TRACKED VEHICLES
E 109 Misc Instr No 1

CARRIER, ARMoured, TRACKED, 15-TON (FV 430 SERIES)

TECHNICAL HANDBOOK - MISCELLANEOUS INSTRUCTION

Fig 1 - Modification to ring spanner FV 650638
(LV9ACR 5120-99-808-2416)

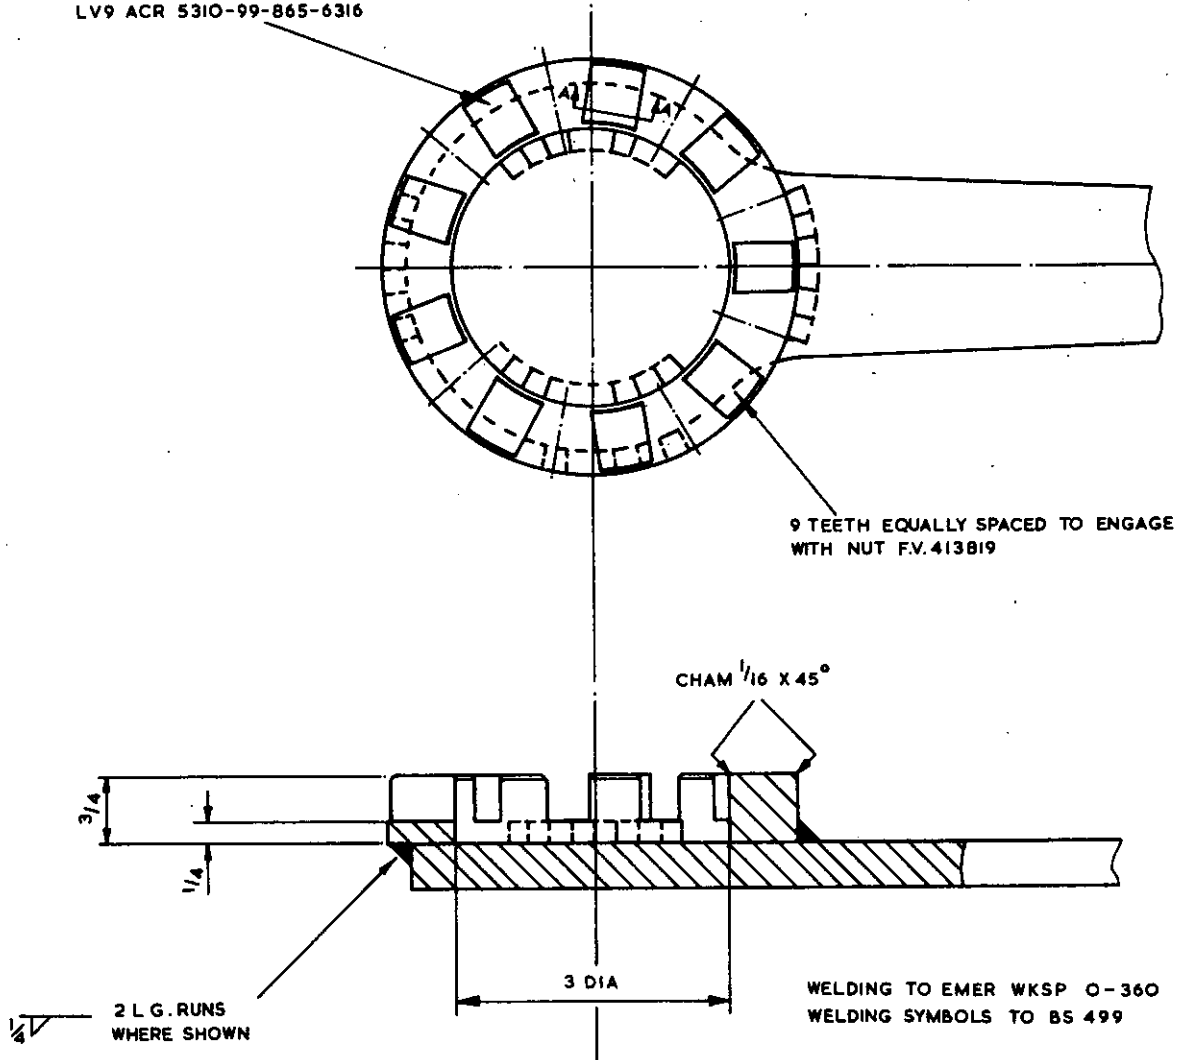
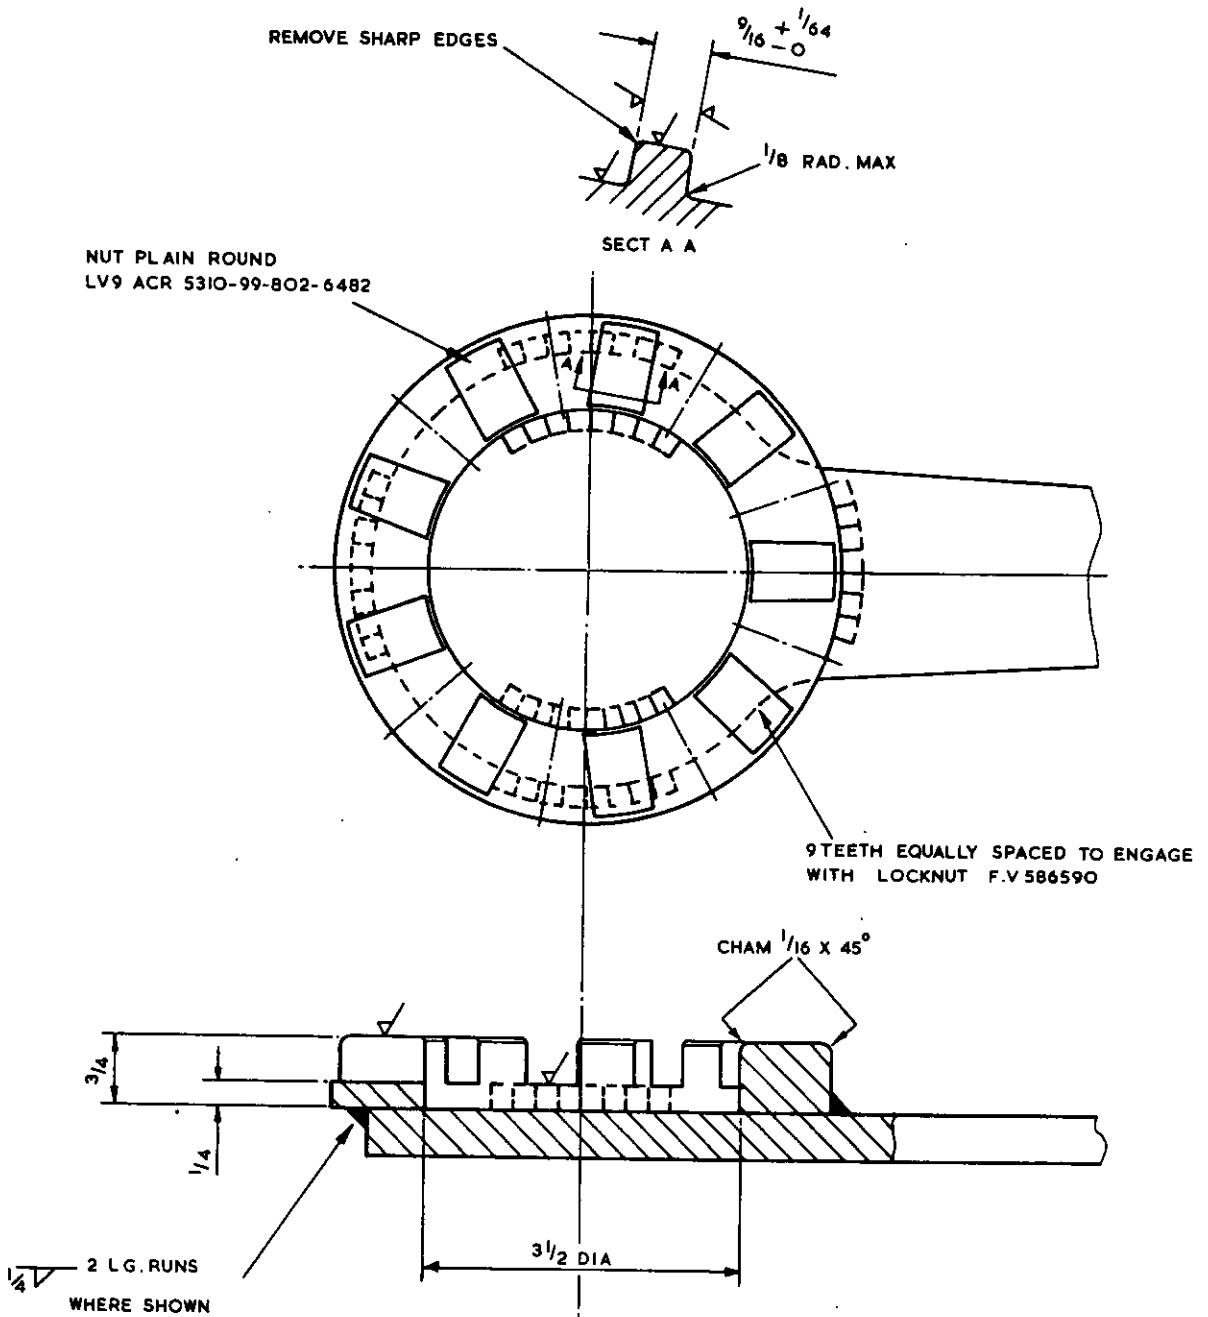
1. The ring nut spanner, is to be modified to provide a drive on all nut slots to overcome in service failure of the existing 3 lug type.

5. a. Obtain the appropriate store as detailed in para 4.
- b. Modify nut, plain, round as detailed in Fig 1 or 2.
- c. Remove the three existing lugs from subject spanner and weld modified nut to spanner as detailed in Fig 1 or 2.

Fig 1 - Manufacturing detail of strengthening plate

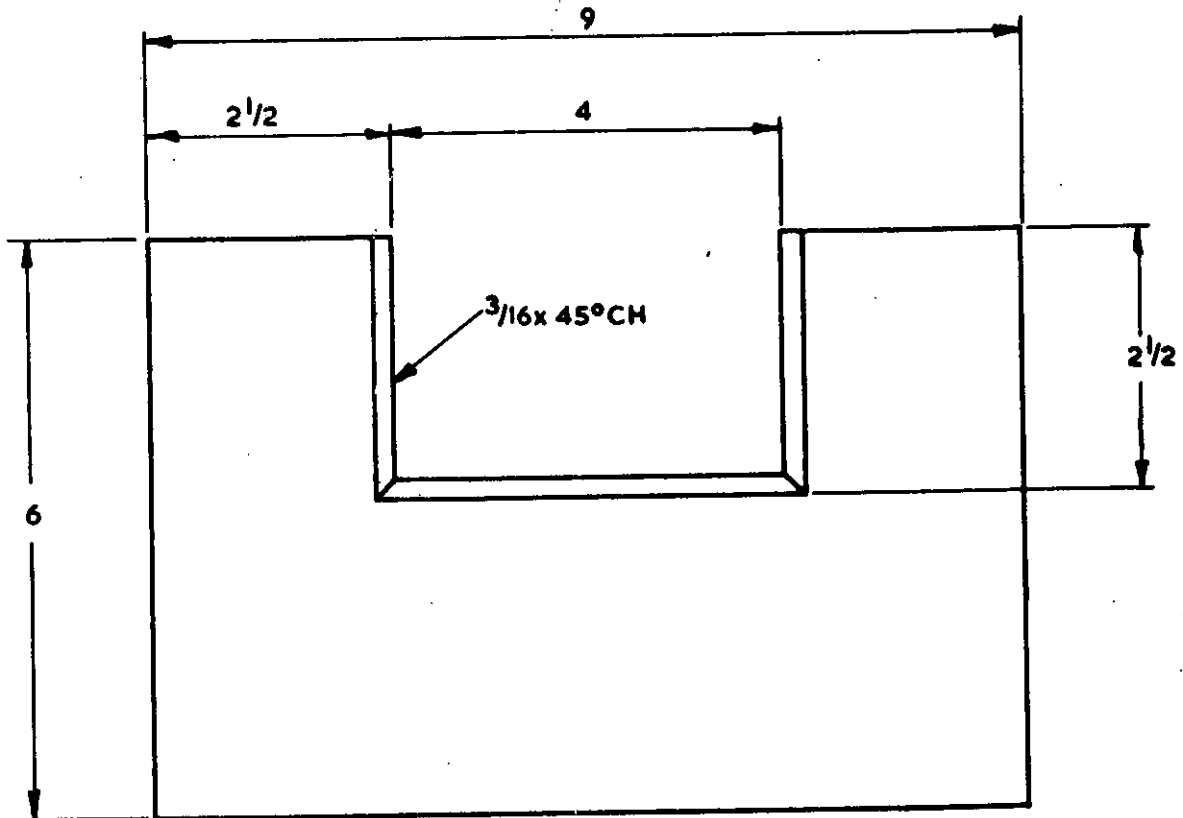
- a. Manufacture plate as detailed in Fig 1 from material detailed in para 4.
- b. Drill the ends of the crack and gauge out the full length
- c. Reweld crack and grind weld flush.
- d. Fit manufactured plate and weld all round including the steering box mounting.
- e. Repaint repaired area.
- f. Carry out modification detailed in Tkd Vehs E 107 Instr No 49 before refitting steering unit.

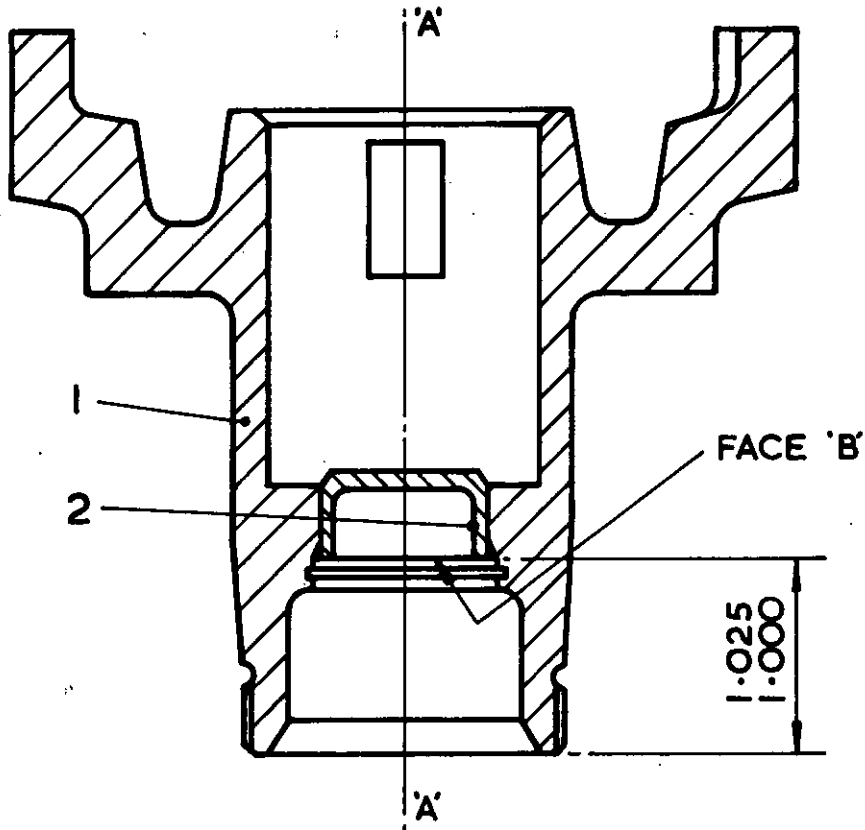
Apply one coat of Sealant H1 8030-99-220-4532 to mating faces and press plug into clutch as detailed in Fig 1. Remove surplus sealant.

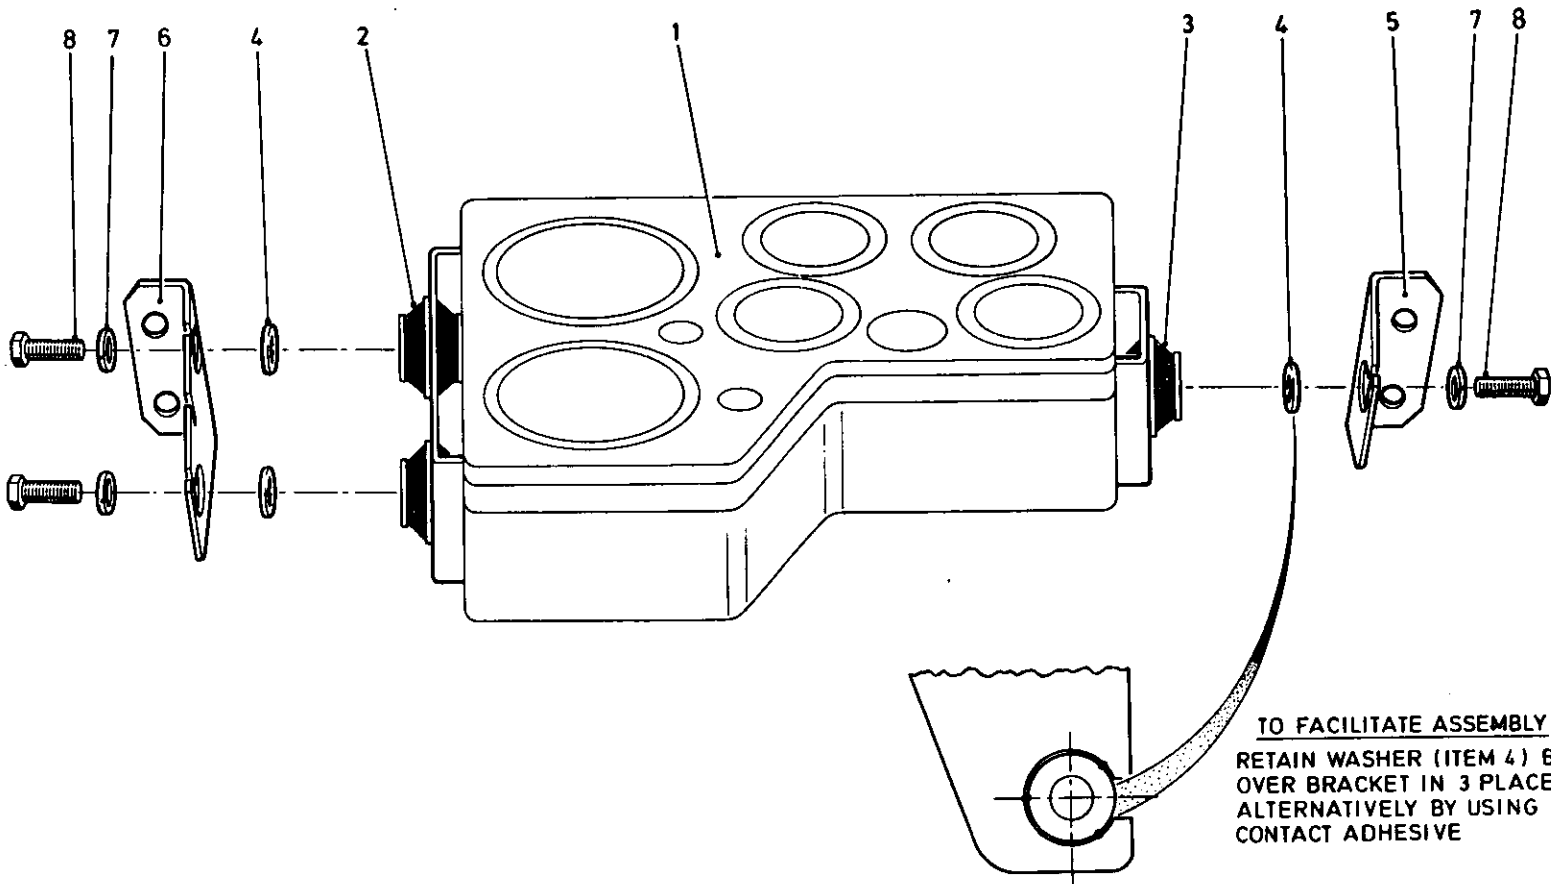
1. Due to the change in pattern of commercial stores, the new mountings do not include the machined spigot diameter which locates in the vehicle mounting brackets. To prevent the instrument panel being dislodged through open slots of mounting brackets under shock conditions, washers are introduced and secured to the bracket recesses.

- a. Using contact adhesive (2), bond washers (1) to bracket FV 603163 and FV 603164 in 3 positions as shown in Figure 1.

Fig 1 - Deflector box

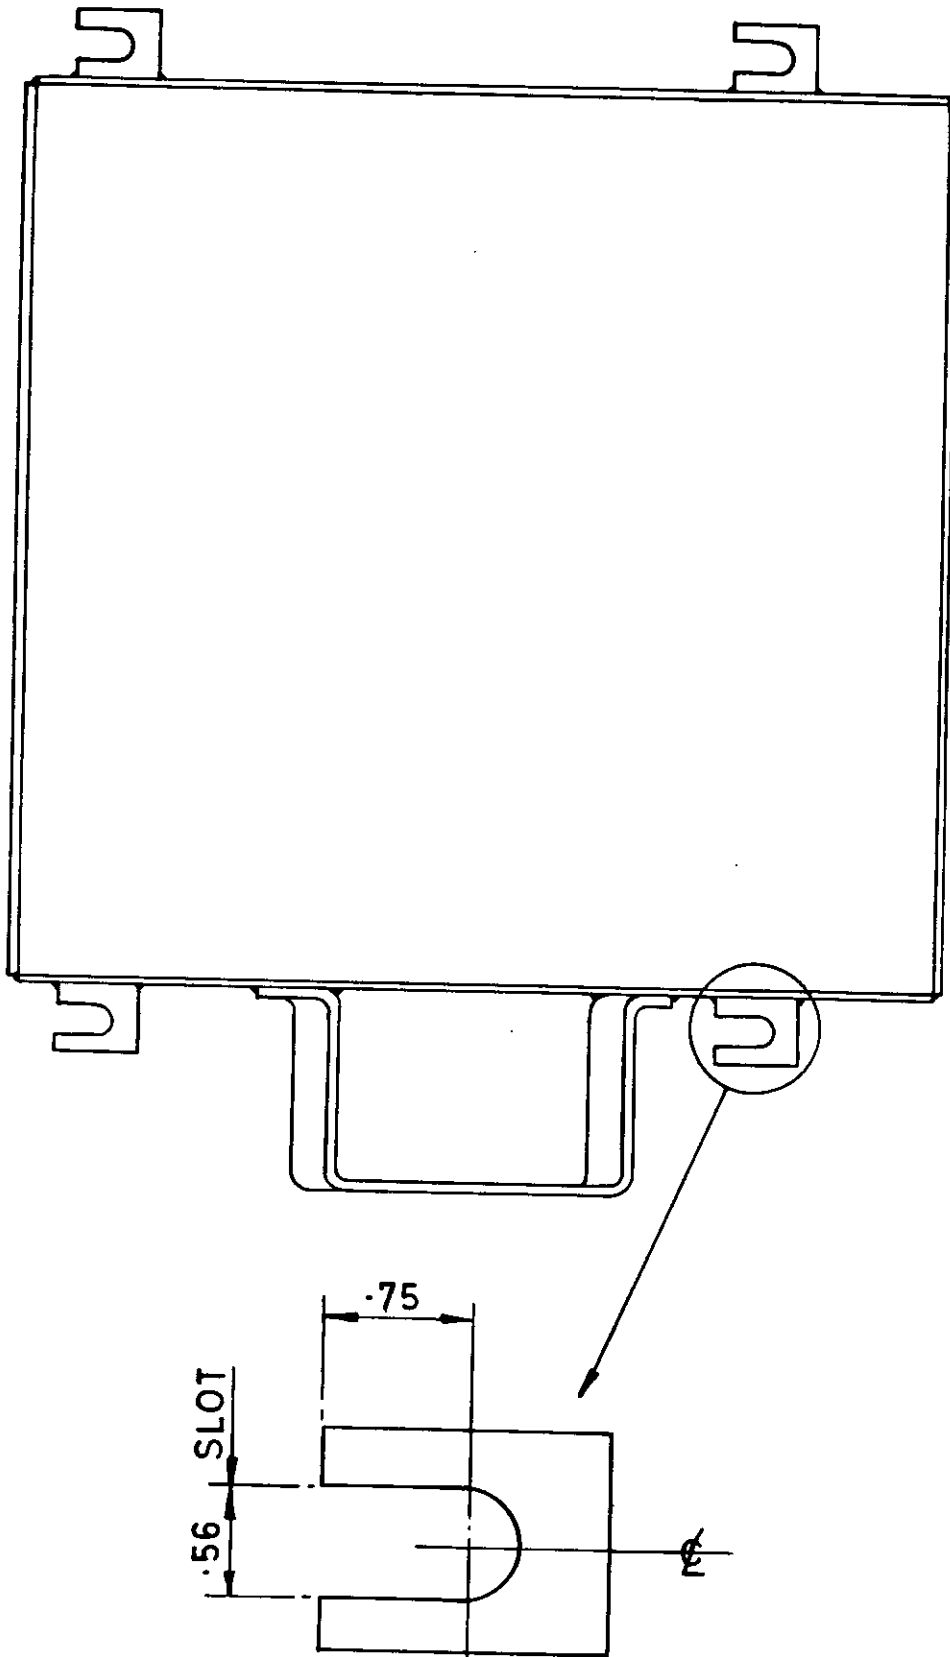
4.1 Cut a slot in each of the four deflector box mounting plates, to the dimensions shown in Fig 1.

Rear top roller bracket modifications
(Dimensions in inches)

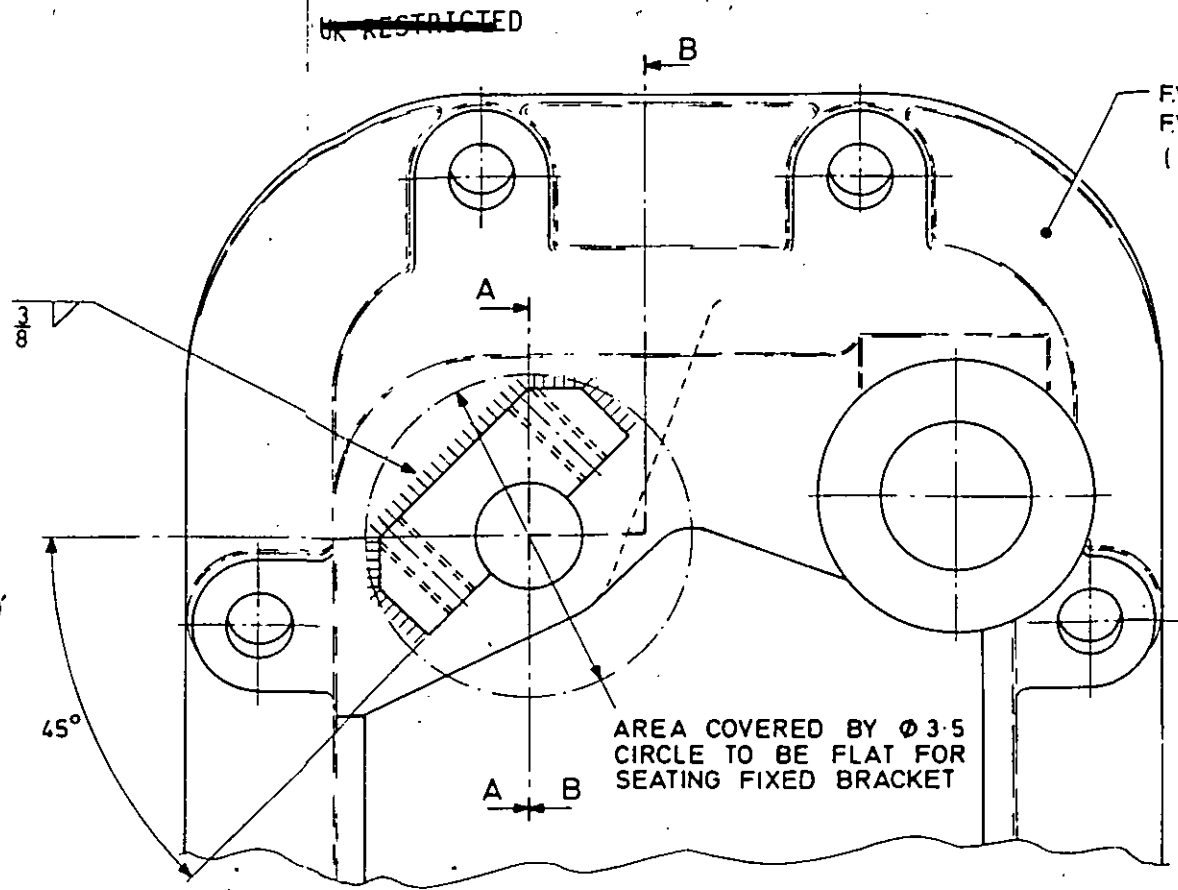
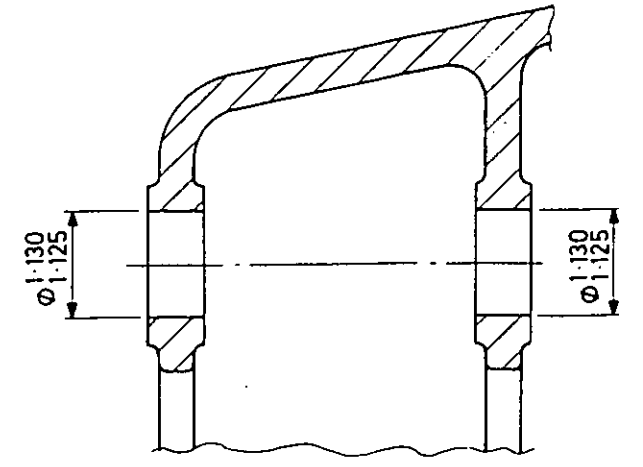
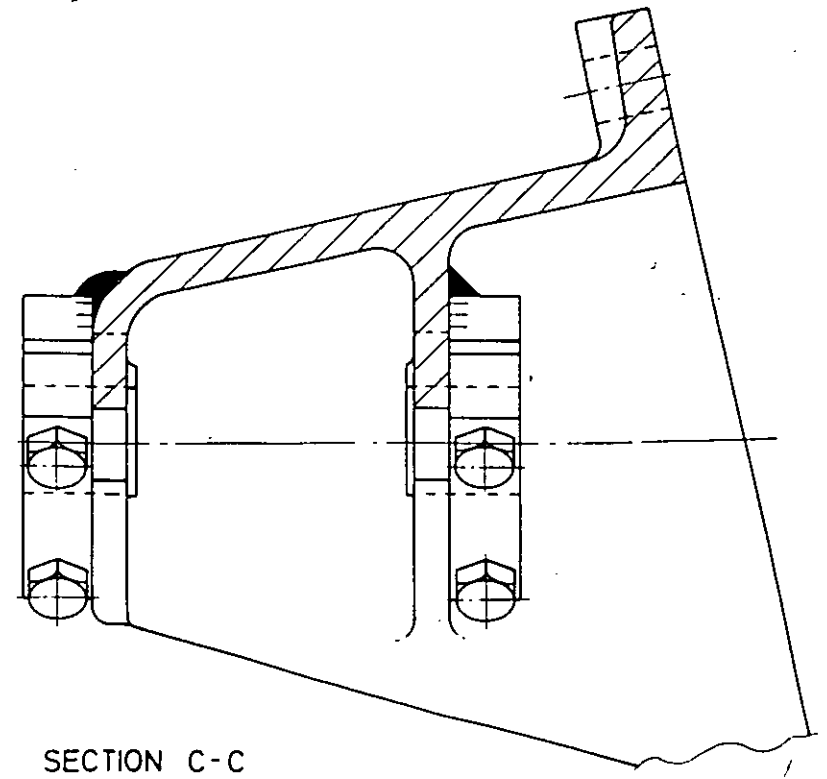
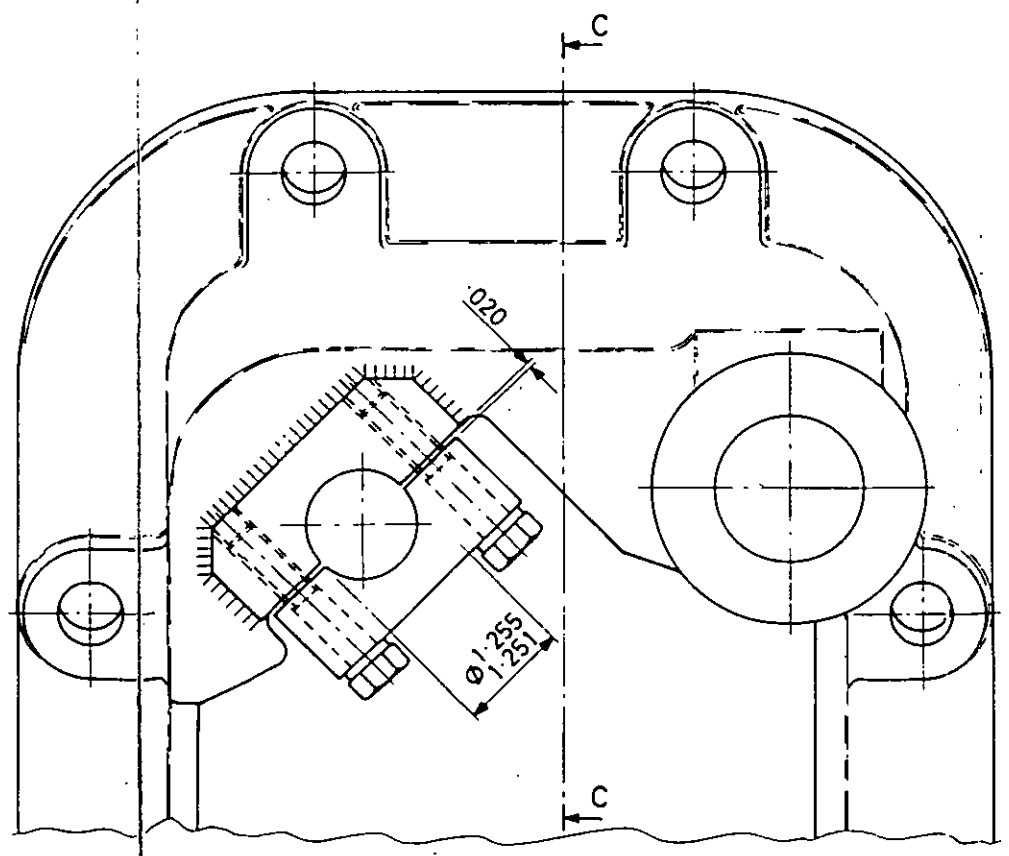
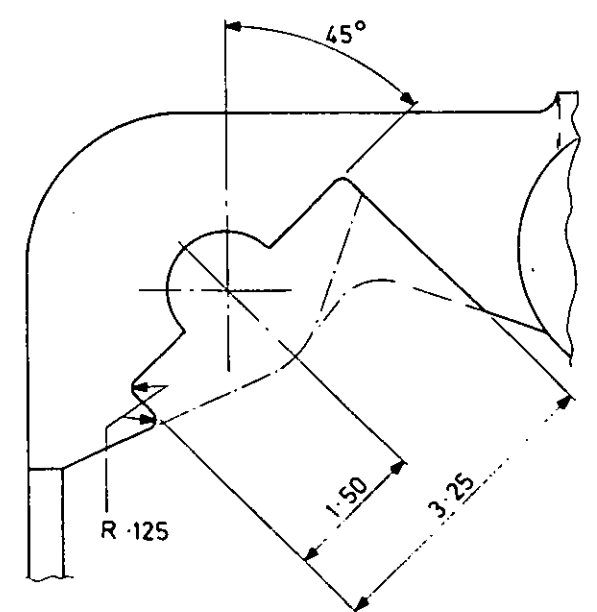
9.11 Remove caps (3) and machine top roller bracket casting (12 and 13) to remove webs allowing for vertical entry of shock absorber bush assy (1) see dimensions view 2/3.
